DESCRIPTIVE REPORT

Type of Survey HYDROGRAPHIC

Registry No. H-11162

Sublocality THORNE ISLAND TO SEAL ROCK

Figure 9 Comparison of Contours

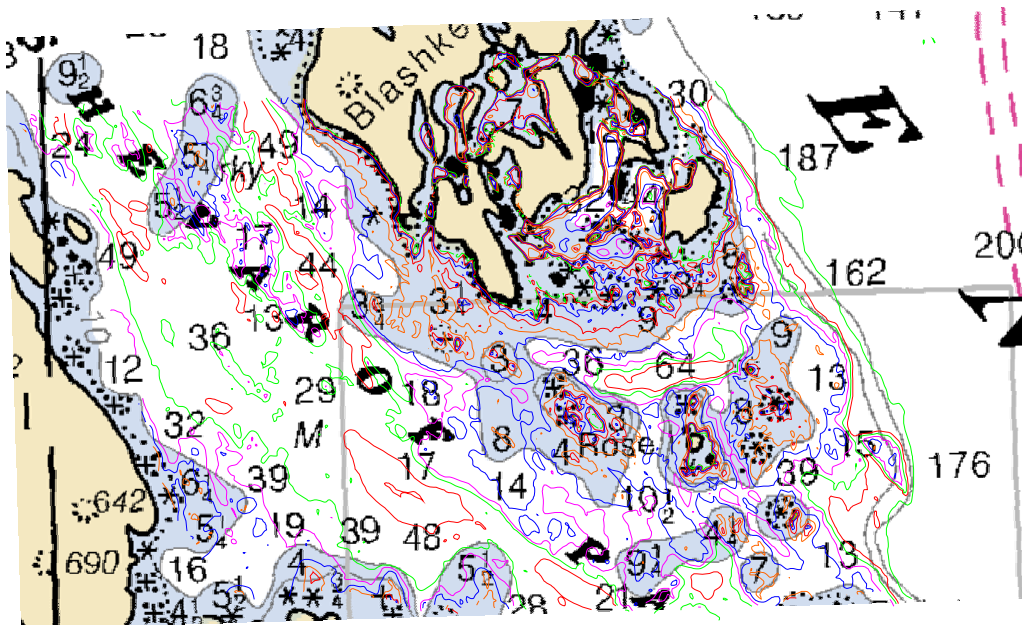
⁴⁰ Note that numerous errors occurred in the depiction of contours on the smooth sheet. Errors have been corrected on the Hdrawings.

Figure 10 DP Correlator Sheet

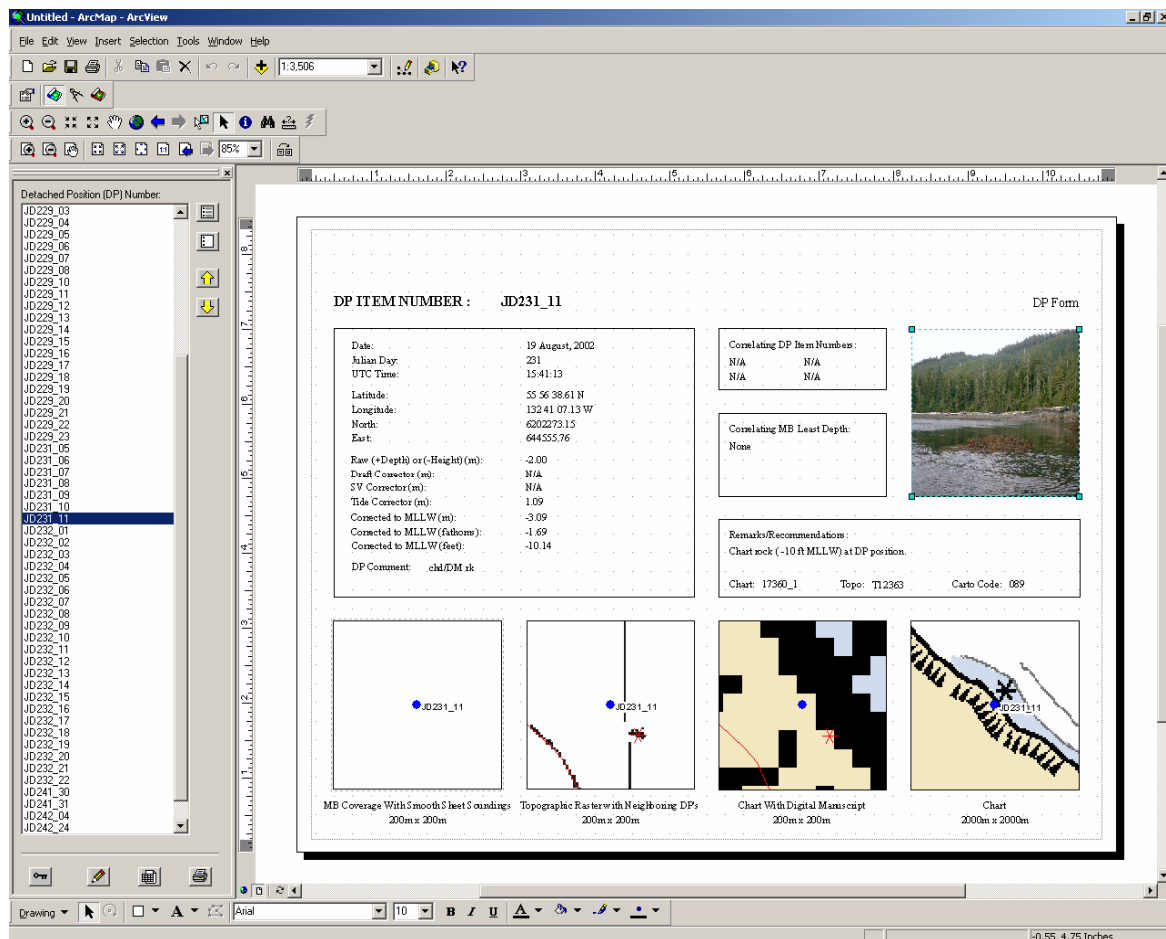
- ⁶⁴ Concur. Chart islet according to the smooth sheet.
- ⁶⁵ Concur. Chart MHWL revision as depicted on the smooth sheet.
- ⁶⁶ Concur with clarification. Chart islet on ledge according to the smooth sheet as recommended on the DP Correlator sheet.

⁷⁴ Concur with clarification. Chart islet surrounded by ledge as depicted on the smooth sheet and recommended on the DP Correlator sheet.

⁷⁶ Concur with clarification. The islet appears on Chart 17382, 16th Edition. The position given in Item 18 is for DP JD244_13. The position of the islet is between the two DP's at Lat 56/6/22.28N and Lon 132/51/15.11W, as stated on the DP Correlator Sheet. Chart islet according to the smooth sheet.
